11<sup>th</sup> January 2016

Ref: CPA\1110116

**Project Planning Services**  
**17 Branch Hill - BIA Audit Report**

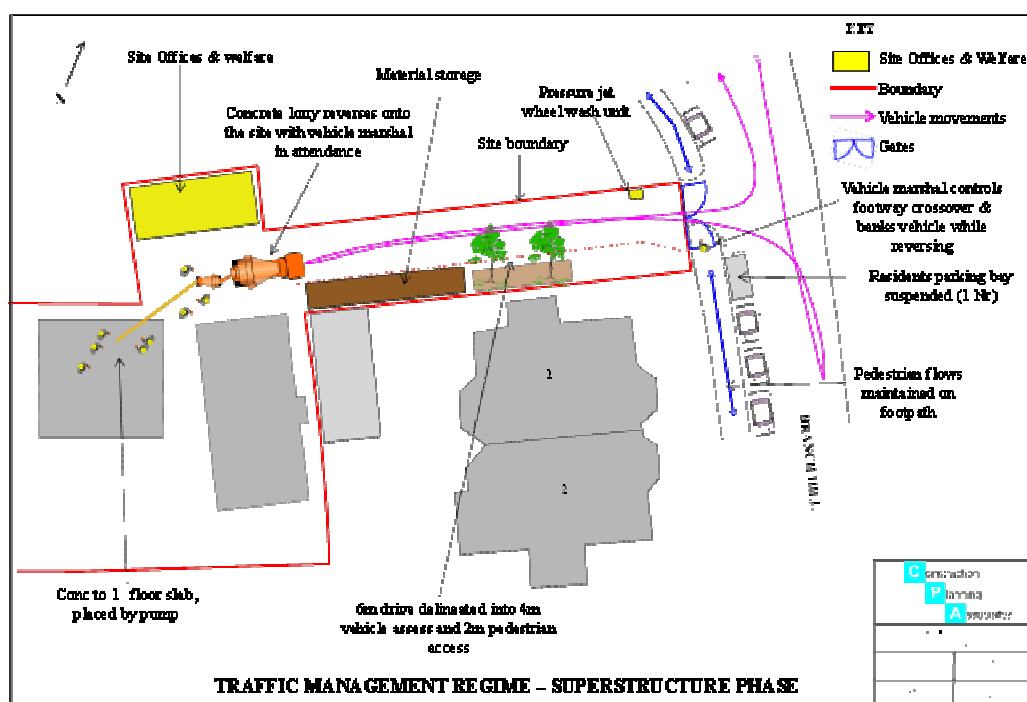
Campbell Reith have raised concerns at the possible surcharge loading on the existing retaining wall that runs along the southern boundary of the access driveway to 17 Branch Hill. This retaining wall varies in height up to a maximum of approximately 2.5 m. The top 0.6 -1.0m comprises a planter which sits above the level of the driveway. (See attached photograph #1), such that the garden to Nr 1 Branch Hill is 2.0m or less below the driveway level.

In preparing the CMP we fully considered stability of this wall and discussed this with the project structural engineers Engineers-HRW and we took account of site dimension measurements of this wall provided by SHH.

We concluded that in order to avoid a potential surcharge on this wall all construction vehicles should be kept at least 2.0m back from the face of the existing wall and thus outside of a 45° zone of influence. In the consented scheme the majority of the existing planters are to be removed, and therefore in this area temporary material storage would be permissible up to an equivalent of the 0.6m-1.0m of soil ( 10-18 kN/m<sup>2</sup>).

This conclusion is reflected in the CMP at paragraph 6 of section 3.5

*The existing planter structure on the southern side of the drive will be demolished except for the section containing two retained mature trees. The driveway will be segregated with a 4m section on the northern side dedicated to the vehicles and the remaining southern section (at least 2m wide) will be used for pedestrian access and material storage. This will ensure the existing retaining wall to Nr1 Branch Hill is not surcharged by any vehicle loading.*
